**DEFENSE NUCLEAR FACILITIES
SAFETY BOARD**

July 25, 2019

Staff Report

Y-12 National Security Complex Criticality Safety Review

Figure 1. NCS Organization Staffing as of January 2019

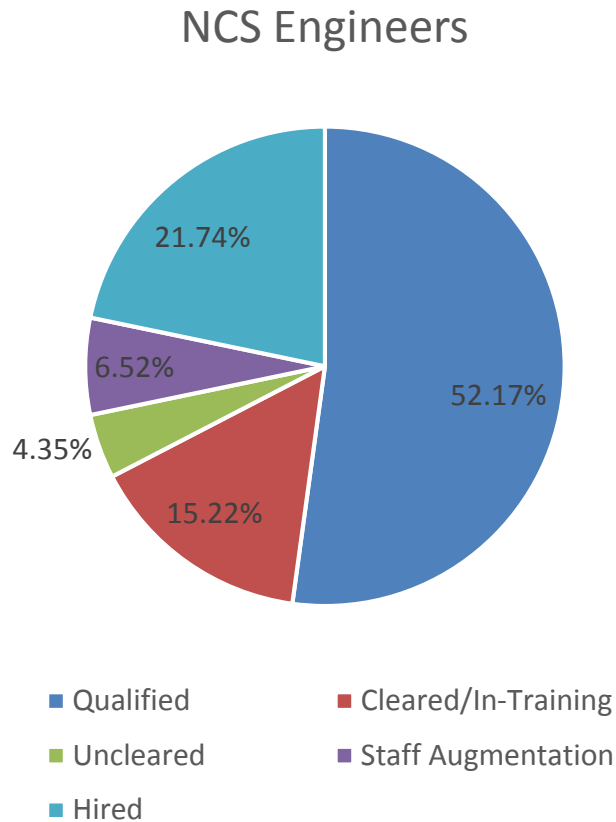
Inability of the NCS Organization to Adequately Maintain the Y-12 Criticality Safety Program—The Y-12 NCS organization lacks sufficient qualified staff to perform both CSP continuous improvement activities and Operations-directed work. As shown in Figure 1, approximately 52 percent of the engineers in the Y-12 NCS organization are qualified (including subcontractors identified as staff augmentation), the remainder are in-training. Qualifications for in-training NCS engineers have been delayed for various reasons, including delays in obtaining DOE security clearances. As of November 2018, the number of qualified NCS engineers does not match the number of NCS engineers required to meet the scope of work budgeted for a given fiscal year. Additionally, the site struggles to retain qualified engineers. On average the number of new NCS engineers hired has equaled the number of NCS engineers lost in a given fiscal year since FY 2015 [18-21].

The staff team acknowledges recent Y-12 efforts to increase NCS staffing. However, the staff team is concerned that the NCS organization cannot sufficiently staff both its commitments to Operations and to perform continuous improvement work on the CSP (e.g., updating/upgrading CSEs) until the number of qualified NCS engineers is increased. The staff team concludes the challenge of retaining NCS engineers will continue to put a strain on the
